UNITED STATES PATENT AND TRADEMARK OFFICE

10/727,210

Office Action Summary	Application No. 10/727,210	Applicant(s) SHIPTON ET AL.	
	Examiner Patrick J. Assouad	Art Unit 2857

DETAILED ACTION

12. The lone Figure of Beer et al. is reproduced below. From their Abstract, we see disclosed:

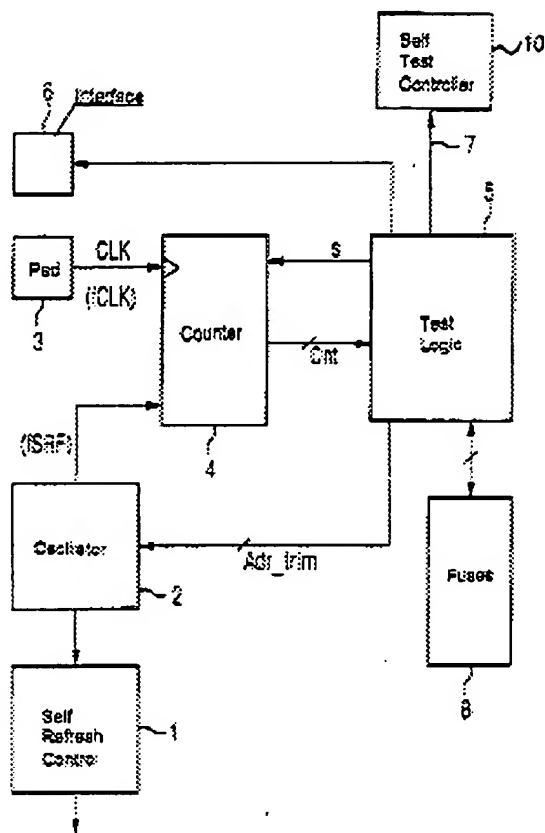
13. The one-to-one correspondence between the instant claimed invention (independent claim 1) and that of Beers et al. is as follows: the processor is controller (10); the onboard system clock is fSRF produced by oscillator (2); the clock trim circuitry is a test logic (5) and fuses (8); receiving an external signal is the external clock signal CLK or fCLK; determining either the number of cycles of the clock signal... is the number of cycles of the clock signal CLK being detected by the counter (4) for n periods, n being a whole positive number; determining a trim value and storing the trim value for controlling the internal clock frequency is performed by the test logic (5) which generates the command ADR_trim at a corresponding correction address to modify or

set or trim the frequency fSRF of the oscillator (2) and note that the correction value may be deposited into the bank of fuses (8).

18. As per dependent claim 13, see at least the external clock signal CLK pad(3) and the (external) Interface 6 of Beers et al.
